**DISTRICT OF WEST VANCOUVER**  
750 17TH STREET, WEST VANCOUVER BC V7V 3T3

## COUNCIL REPORT

Date:	October 4, 2024
From:	Megan Roberts, Assistant Planner
Subject:	Preliminary Development Proposal for 1485 Clyde Avenue
File:	05-1020-01-2024

**SECOND FLOOR PLAN FLOOR AREA: 3362.5 sf**  
**SCALE: 1/8"=1'-0"**

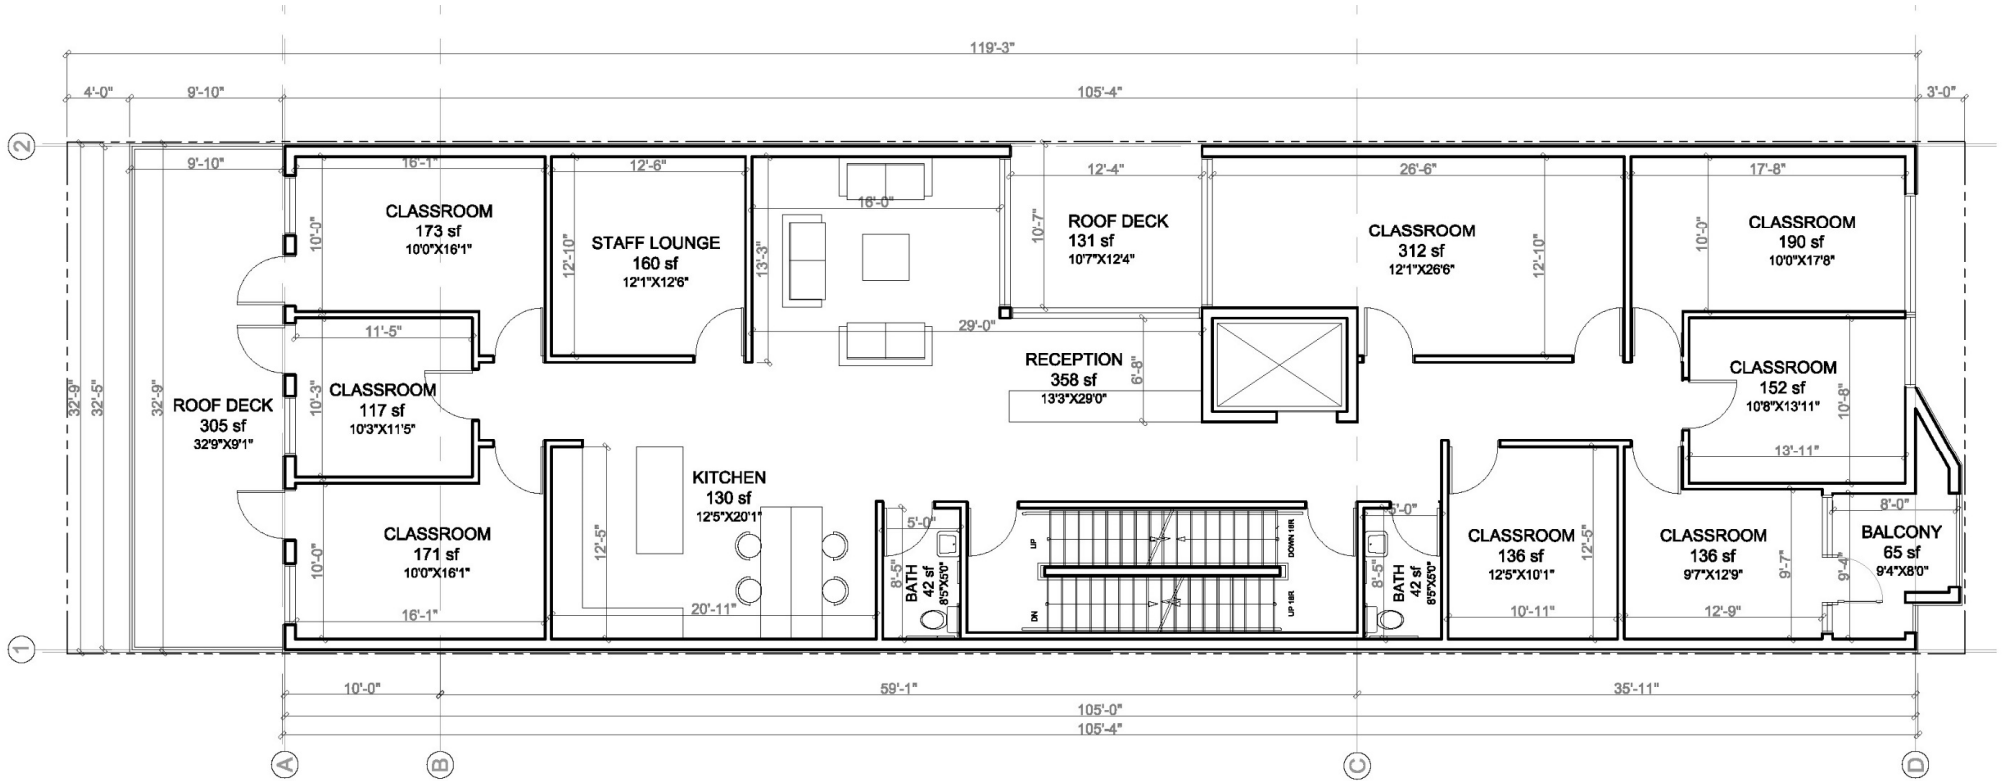
- **Uses:** Confirmation of the proposed uses of the commercial areas on the first and second storey and how parking would be accommodated for the commercial unit tenants will be required. The second storey floor plans indicate classrooms and a staff lounge. While the AC1 zone permits education, if a school is permitted, this may contribute to peak parking demand and pick up and drop off activity associated with this use. In terms of current LAP directions, retail at street level with commercial above and secured rental housing are consistent with broad LAP objectives.
